ADDENDUM NO. 1

Project Name: Hobart Park Baseball Field Project

Bid Number: 2020005

This addendum is being released to answer questions received to date, to modify the bid documents, and to provide the pre-bid meeting minutes.

COLLEGE BASEBALL FIELD DETAILS & GRADING

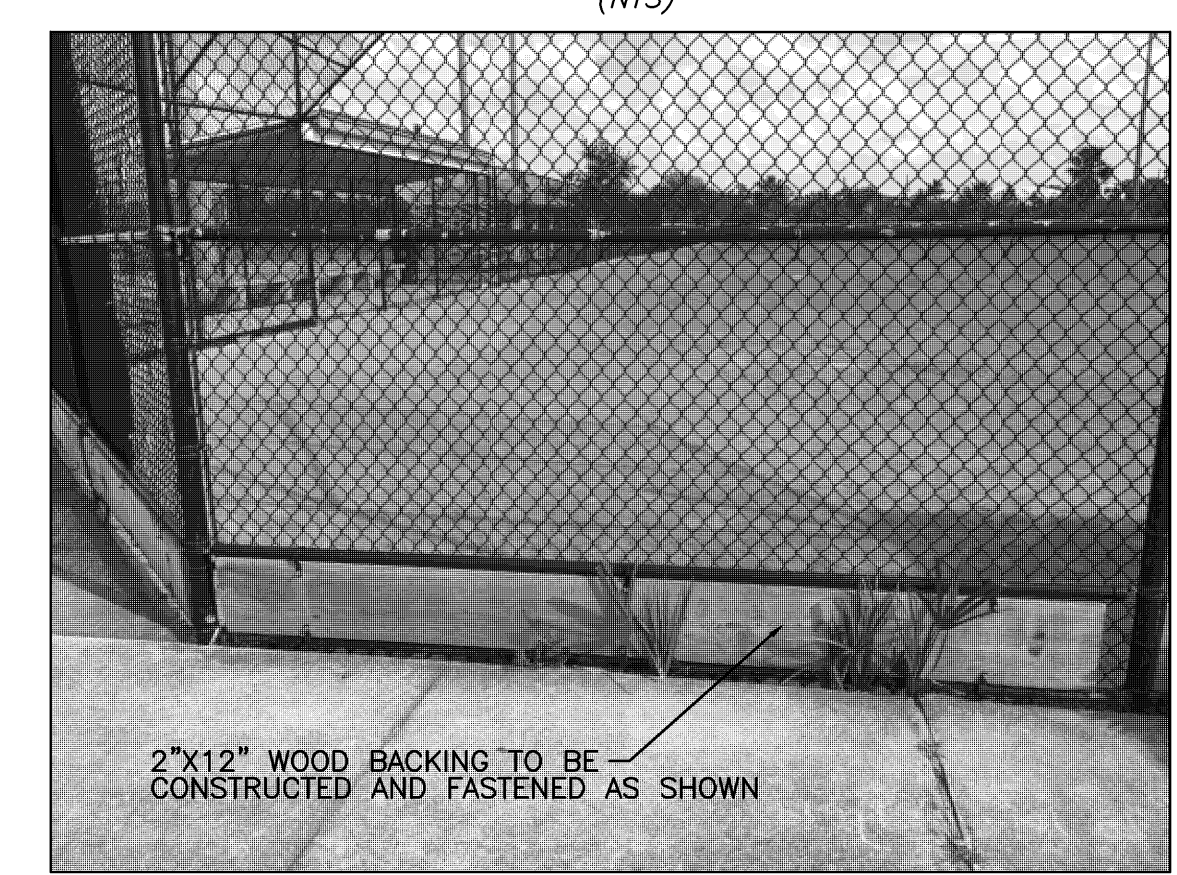
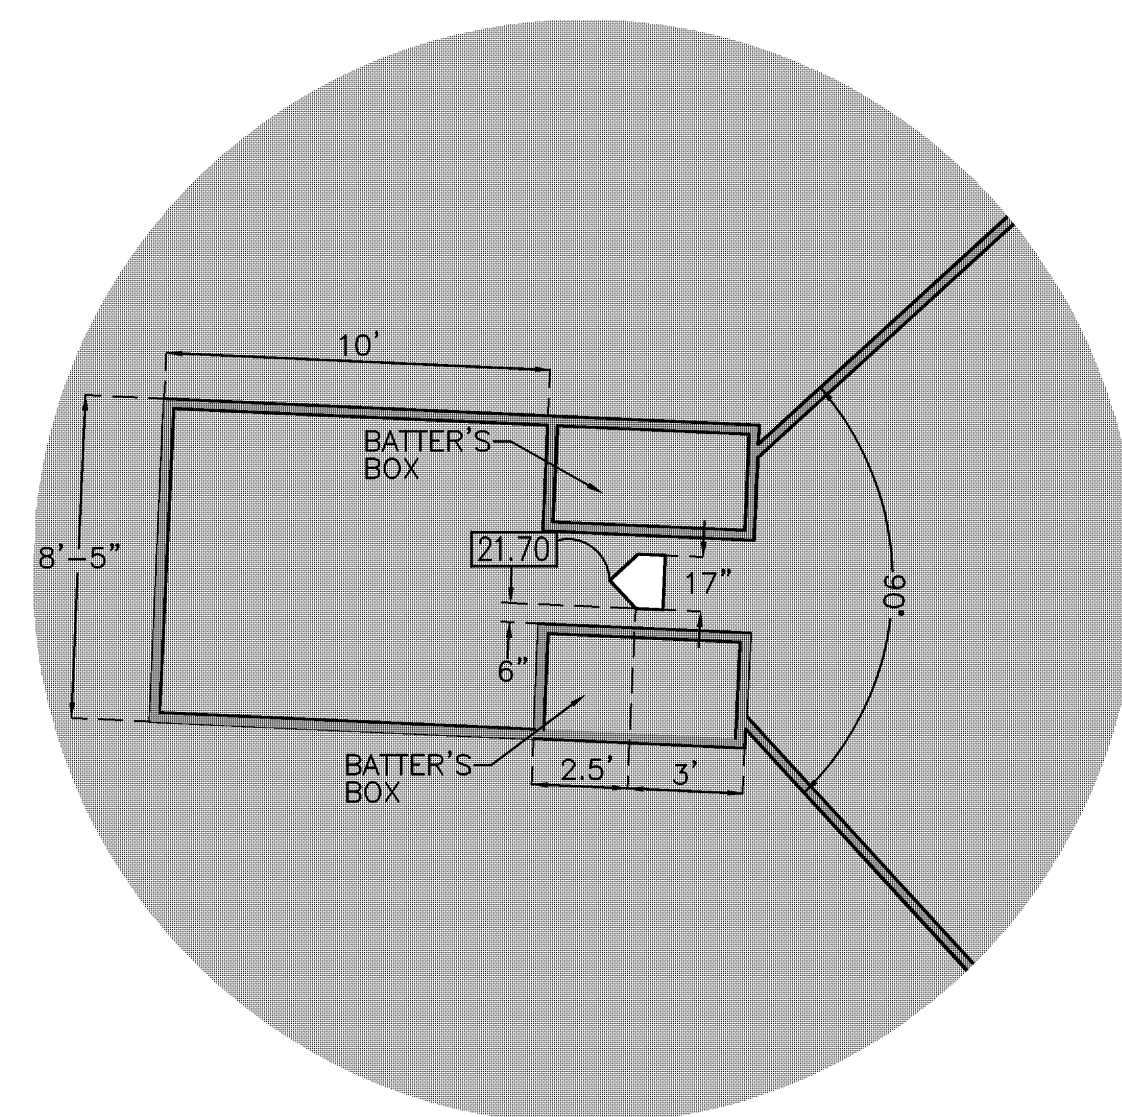
1. The fence from the backstop to the end of the bull pen areas have been increased in height from 6' to 10';
2. The fencing surrounding the bullpen areas has been raised from 6' to 10';
3. The Dugout details have been revised to clearly depict 10' high field protective fencing as not being supported by the dugout structure columns.

NO.	DATE	DESCRIPTION	DR/APP
1.	9/11/19	REVISED CHAIN LINK FENCE HEIGHT	SH/SEM
2.	6/11/18	REVISED PER IRC TRC COMMENT LETTER OF 6/14/18	SH/SEM
1.	5/10/18	REVISED PER IRC PRE-APP COMMENTS	SH/SEM

SOFTBALL/HYBRID FIELD DETAILS & GRADING

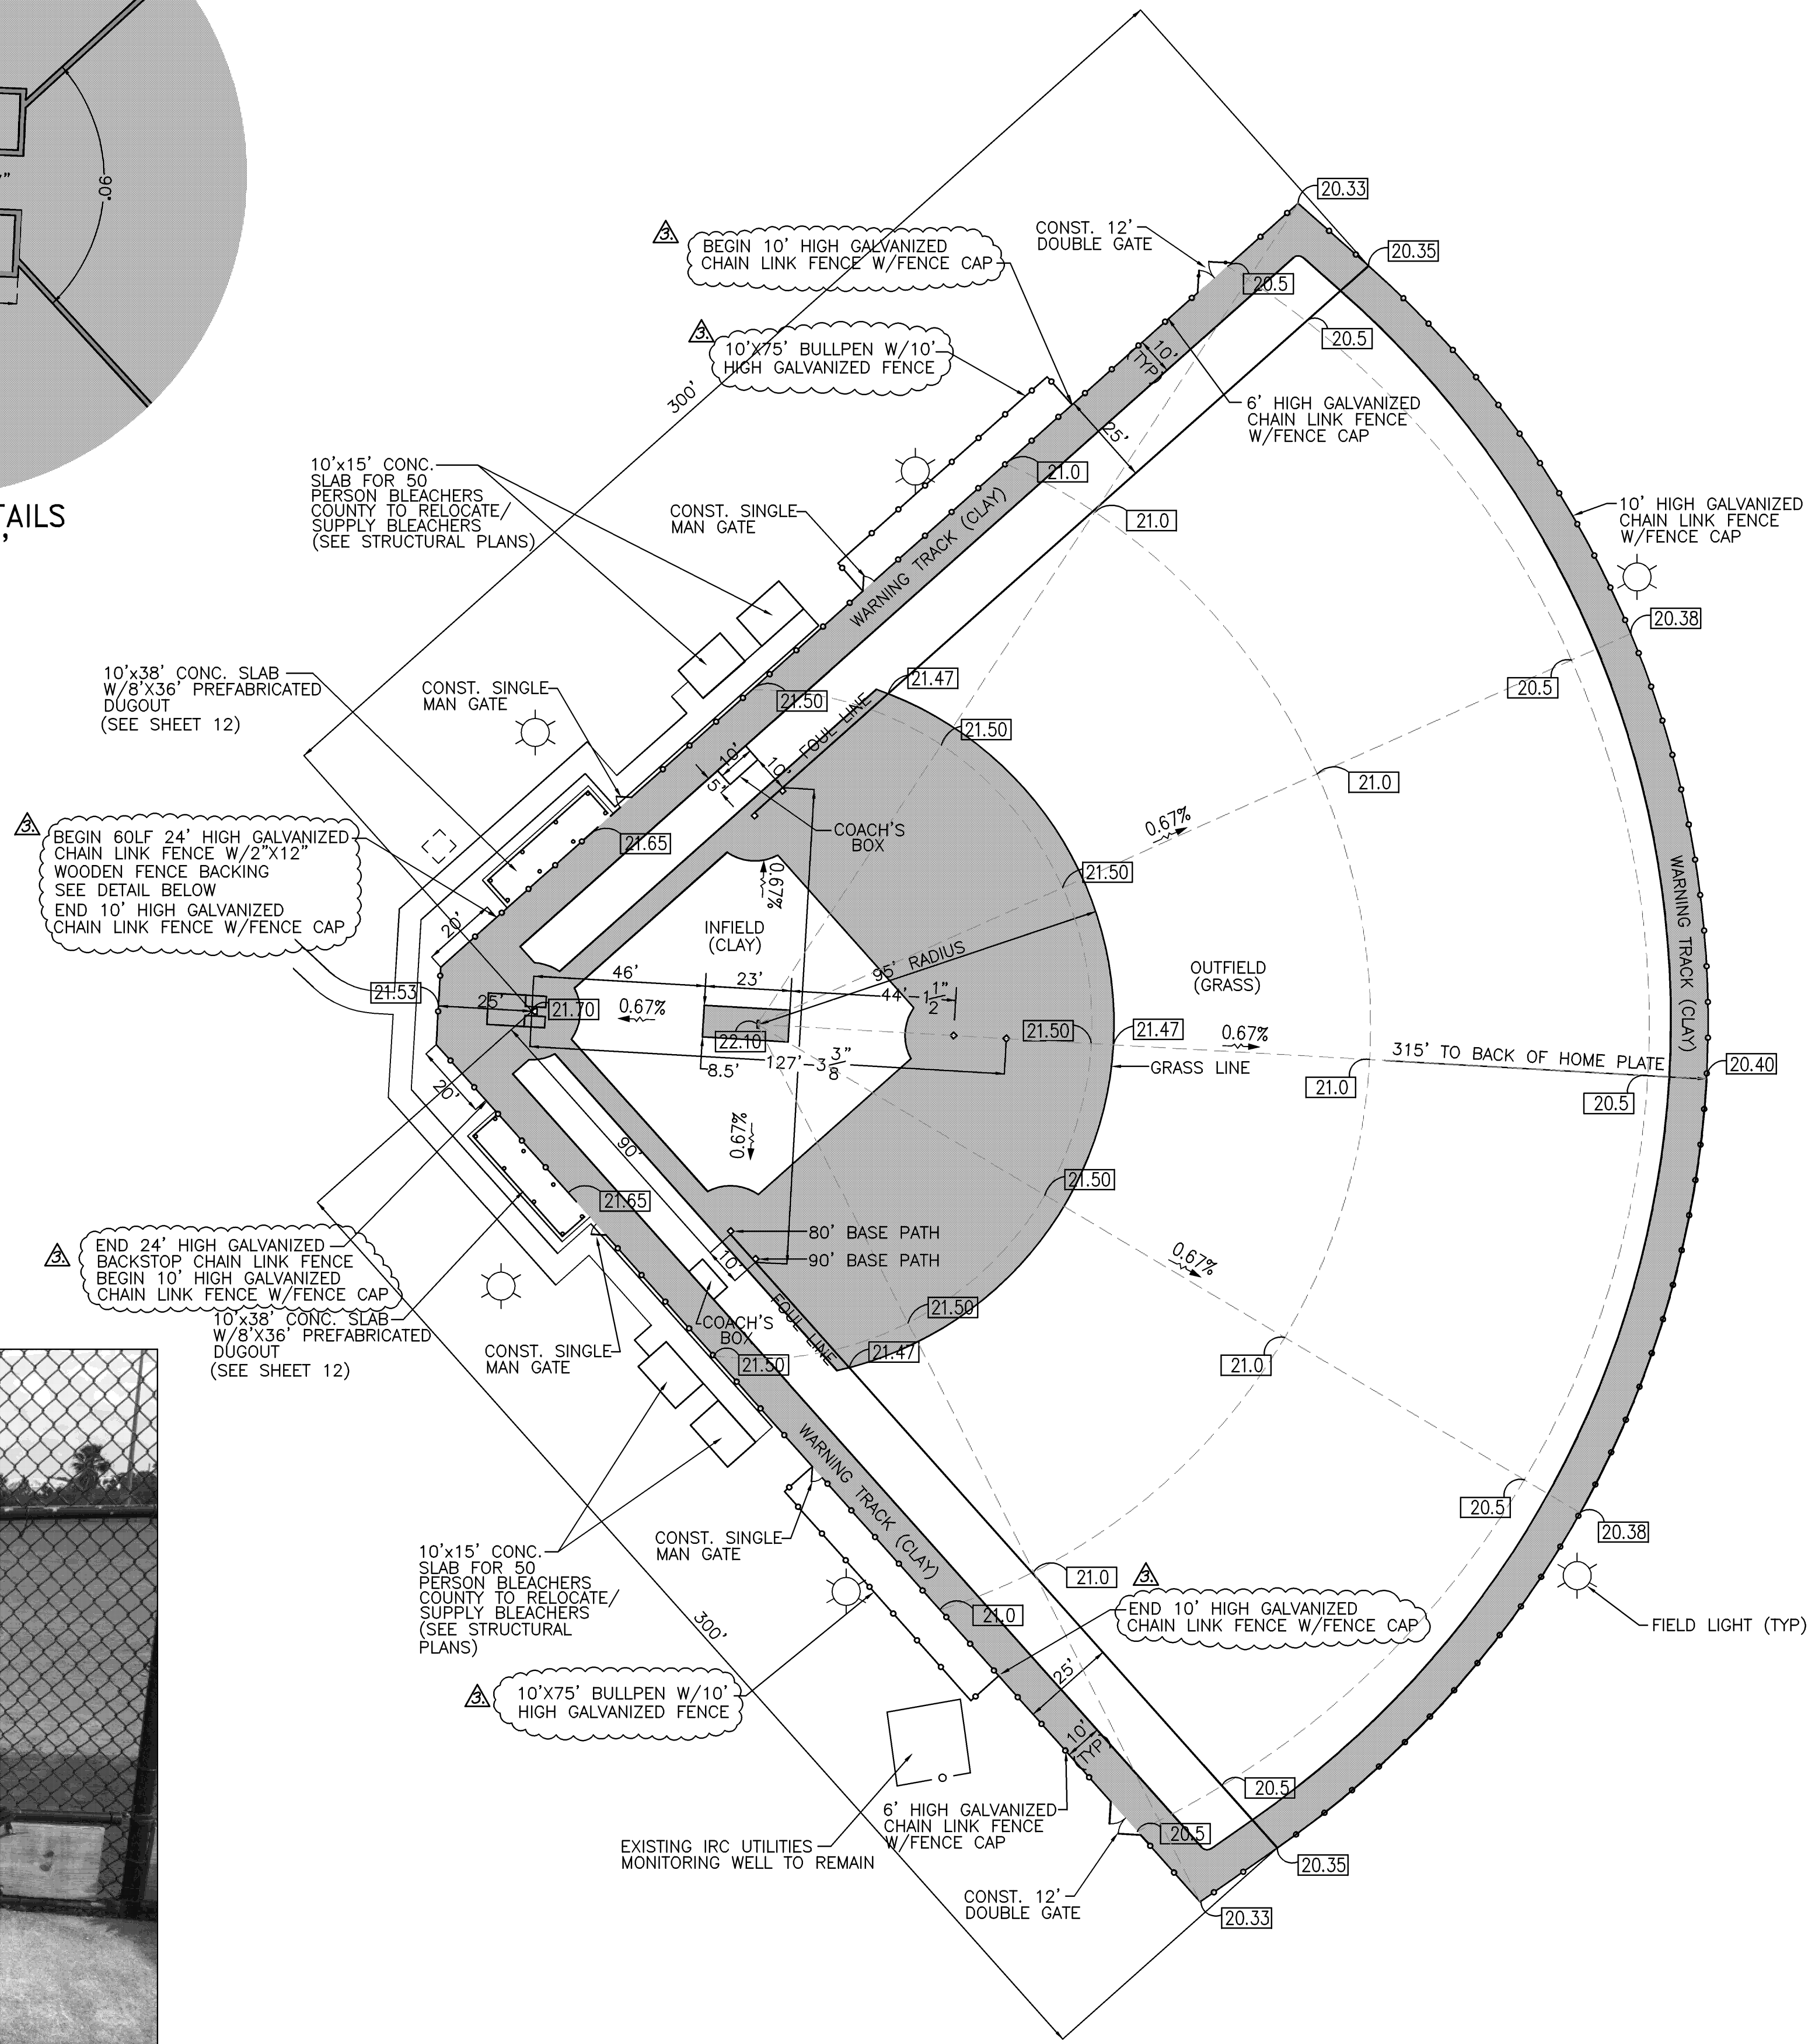
NO.	DATE	DESCRIPTION	DR/APP
REVISIONS			
1.	5/10/13	REVISED PER IRC PRE-APP COMMENTS	SH/SEM
2.	6/11/13	REVISED PER IRC TRC COMMENT LETTER OF 6/14/13	SH/SEM
3.	9/11/14	REVISED CHAIN LINK FENCE HEIGHT	SH/SEM
